CITY OF HENDERSONVILLE
Cherry and Beech Sidewalks Project

ADDENDUM NO. 2

February 21, 2025

C7

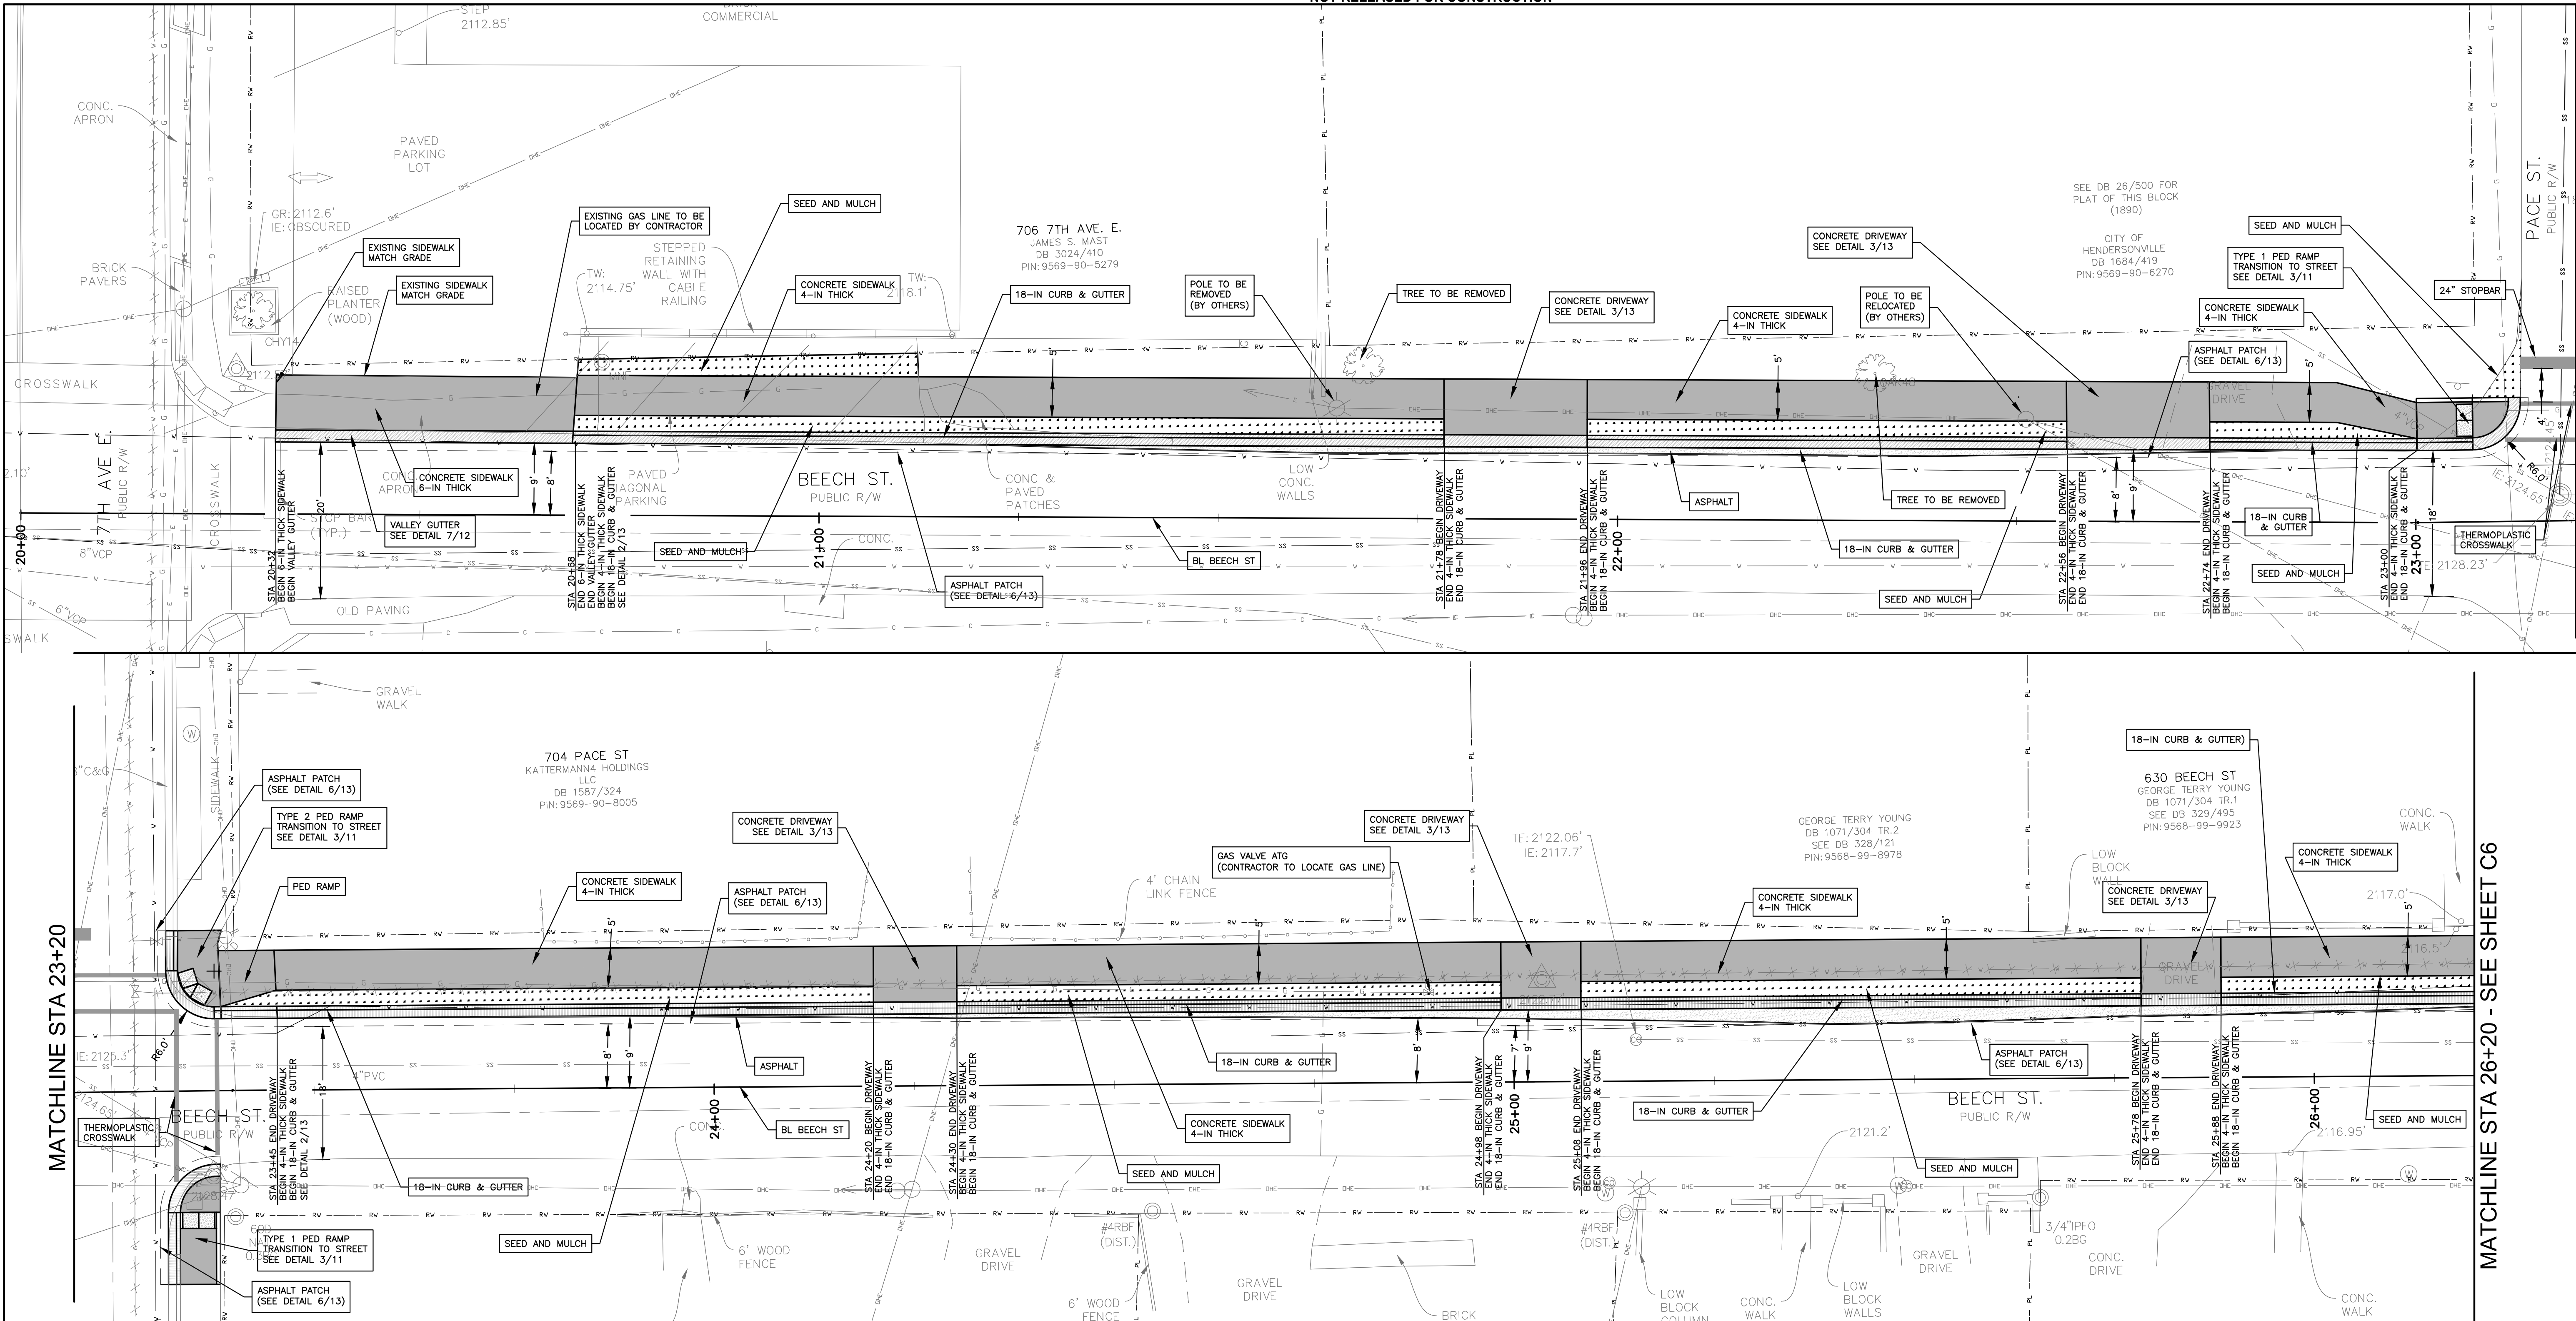
- a. Drawings have been updated to remove milling from the Work, clarify asphalt patching, clarify demolition extents, and show thermoplastic crosswalk lines.
- b. Demolition hatch extended to match sawcut boundary sheets C4, C5, and C6.
- c. MILL AND ASPHALT OVERLAY removed from sheets C7, C8, and C9.
- d. SAWCUT ASPHALT AND REPLACE 1' FROM EOP removed from sheets C7, C8, and C9.
- e. END 6-IN HDPE PERFORATED PIPE FOR 2'X2' BIOSWALE removed from sheet C7.
- f. ASPHALT PATCH added to sheets C7, C8, and C9.
- g. 6" WHITE PAINT CROSSWALK removed from sheets C7, C8, and C9.
- h. THERMOPLASTIC CROSSWALK added to sheets C7, C8, and C9.
- i. 24" STOPBAR added to sheets C7, C8, and C9.
- j. This updated set is attached to this addendum.
